Submission to the HumeLink, Material Change in Circumstance Assessment, by HumeLink Alliance Inc., April 3, 2024

1. Introduction

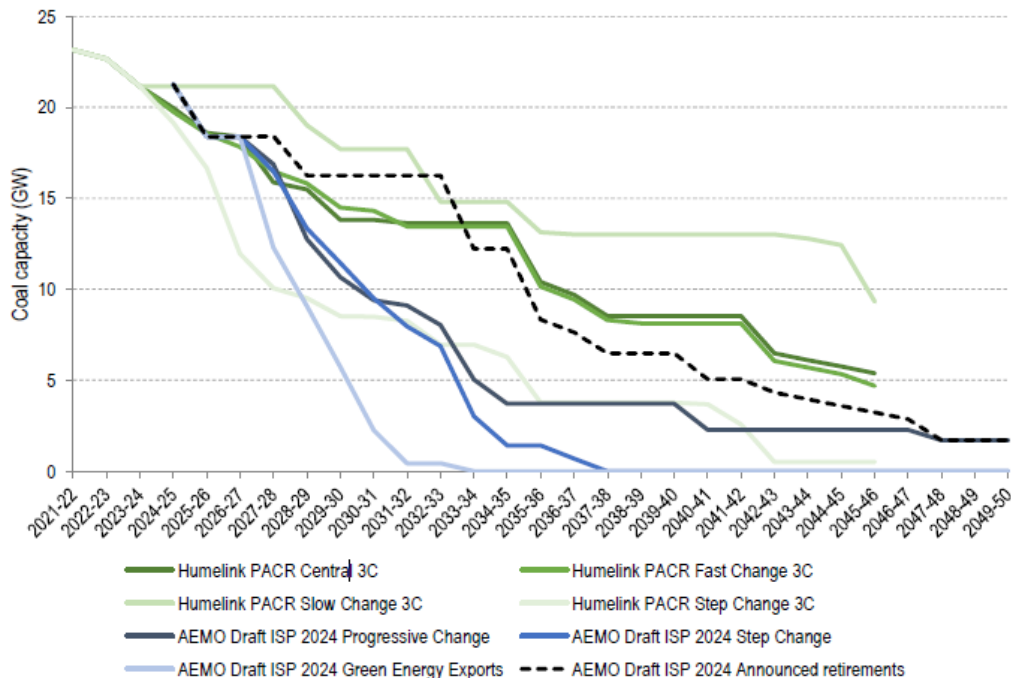
In the MCCA, the largest benefit category is the 'avoided costs for non-RIT-T proponent parties.' This benefit category captures the generation and storage costs in the base case that are avoided from building Humelink. Transgrid is saying that Humelink unlocks capacity from Snowy 2.0 and unlocks areas where additional wind generation can be developed, which avoids the cost of building (more expensive) solar and batteries that would have been required in the base case to meet our emissions reduction targets. In the MCCA, the avoided cost for non-RIT-T proponents accounted for gross benefits of \$7.26b (more than 90% of the total gross benefits). In contrast, this benefit category was around \$1.32b in the PACR. The differences in time period and discount rate identified above do not by themselves account for this difference.

There appear to be two key reasons for the substantial growth in this benefit category:

Figure 12: Forecast capacity difference with and without HumeLink Option 3C, commissioned 2026-27 for the Step Change scenario

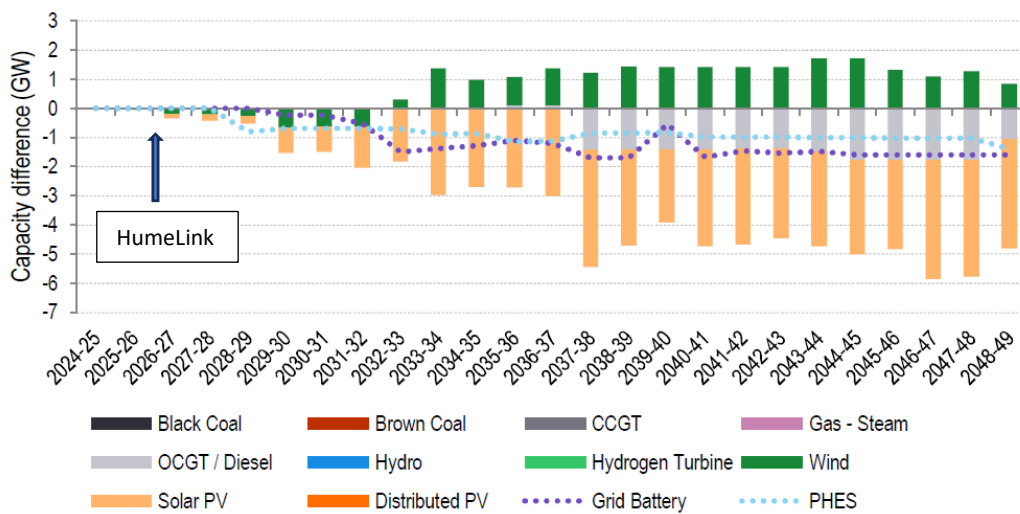
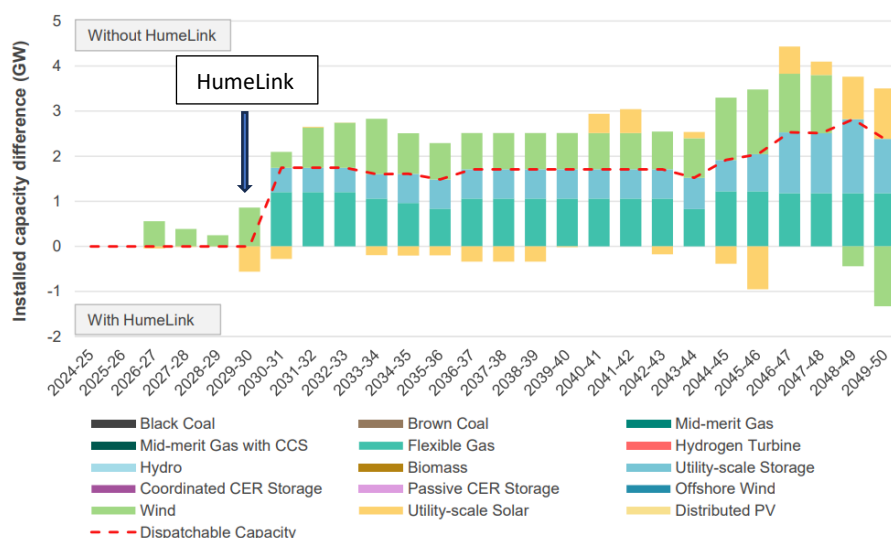
A cause for this disparity can be seen from the figures below, which shows that EY are estimating that significantly more solar is displaced from connecting Humelink than AEMO.

However, the sheer size of the disparity between the benefits estimated by EY and AEMO brings into question the veracity of EY's market model.

EY attempt to explain these differences in their report (section 7). However, EY note even accounting for differences in assumed commissioning date, the gross benefits computed by EY are higher than those computed by AEMO.

None of these reasons are sufficient to explain the night and day differences in the modelling outcomes of EY and AEMO.

Figure 1: Comparison of PACR and MCCA pumped hydro generation in the base case

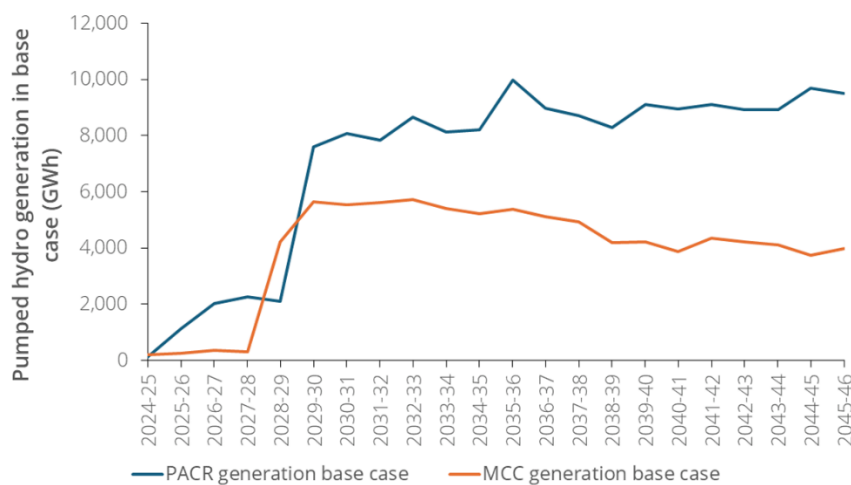
In the MCCA, Transgrid has assumed that generation capacity at Snowy 2.0 will be limited to 660MW in the absence of Humelink. This is based on an equivalent assumption made by AEMO in the 2023 IASR. This is a key change from the PACR where this constraint was not applied. Transgrid notes that this ‘constraint has a material effect on the market benefits estimated for each of the credible options in this MCC assessment, as they can each unlock the material levels of generation and long duration energy storage capacity that is provided by Snowy 2.0.’ Figure 1 below shows a clear drop in pumped hydro generation in the base case between the PACR and the MCCA. (Figure 1 is indicative only, given the differences in the scenario descriptions).

This change raises serious questions about the MCCA for several reasons, as follows:

- Little **evidence to support the change** – The MCCA only refers vaguely to ‘*Further in-depth studies performed by Transgrid*’ and that the ‘*constraint arises from network congestion in the southern part of Transgrid’s transmission network and limited line capacity between Lower Tumut and Upper Tumut.*’ There is no independent validation of the 660MW export constraint. Given that this export constraint on Snowy 2.0 has a significant impact on the market benefits estimate, Transgrid must provide further information on how it was derived.

- It is a **fundamental change to the base case** – a key objective of the RIT-T is to assess credible options against a consistent base case. By introducing a constraint on Snowy 2.0’s generation capacity without Humelink, it means that the base case used for the purposes of the PACR (and the PADR before it) is different to the base case used for the MCCA. This means that the credible options identified in the PADR/PACR have been assessed on a different basis to the credible options in the MCCA. This raises the question of whether some of the options that were previously discarded at the PACR stage should now be reassessed against the new base case, or indeed whether there are other options that have not been previously identified that should be considered.
